Access Compliance Report

Public Rights-of-Way

Intersection ID: 51443	Main Street: SHARON_RD	Cross Street: ASHLEY_PARK_LN	Location: NE
ADA ID: EA7362325890	Ramp Type: Perp	Initial Pass/Fail: Fail	Overall Compliance: No
		Severity Score: 10

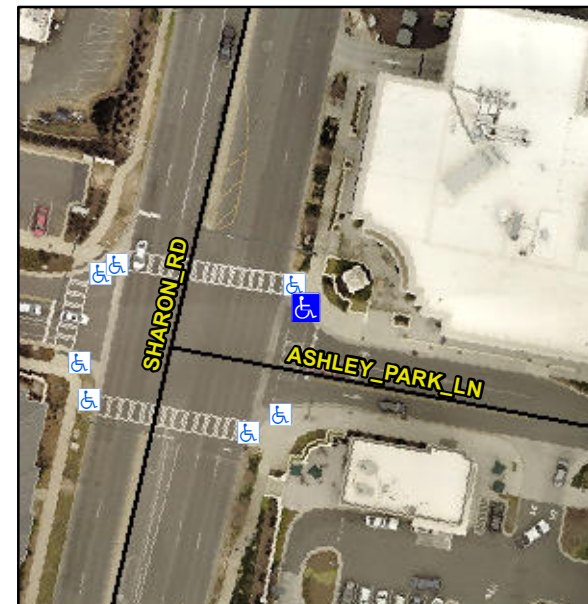
Not Found, R304.5.1, R304.5.3

Compliance	Description	Data	Compliance	Description	Data
N/A	Ramp Length (in)	81.0	Yes	Ramp Slope (%)	7.4
No	Ramp Width (in)	44.0	No	Ramp XSlope (%)	5.0
N/A	Flare Type LT	N/A	N/A	Flare Type RT	N/A
N/A	Flare Slope LT (%)	N/A	N/A	Flare Slope RT (%)	N/A
N/A	Flare Traversable LT?	N/A	N/A	Flare Traversable RT?	N/A
N/A	Landing Length (in)	N/A	N/A	DWS Provided?	N/A
N/A	Landing Width (in)	N/A	N/A	DWS Contrast?	N/A
N/A	Landing Slope (%)	N/A	N/A	DWS Length (in)	N/A
N/A	Landing X Slope (%)	N/A	N/A	DWS Full Width?	N/A
N/A	Landing Curb? (Y/N)	N/A	N/A	DWS Offset (in)	N/A
N/A	Shared Landing?	N/A			
N/A	Gutter Ponding?	N/A	N/A	Gutter Slope (%)	N/A
N/A	Gutter Lip Ht (in)	N/A	N/A	Gutter X Slope (%)	N/A
N/A	Painted X Walk1?	Yes	N/A	Painted X Walk2?	N/A
	X Walk 1 Direction	To SW		X Walk 2 Direction	N/A
N/A	X Walk 1 Width (in)	106.0	N/A	X Walk 2 Width (in)	N/A
	X Walk 1 Slope (%)	1.8		X Walk 2 Slope (%)	N/A
	X Walk 1 X Slope (%)	2.9		X Walk 2 X Slope (%)	N/A

Remove & Replace Entire Ramp.
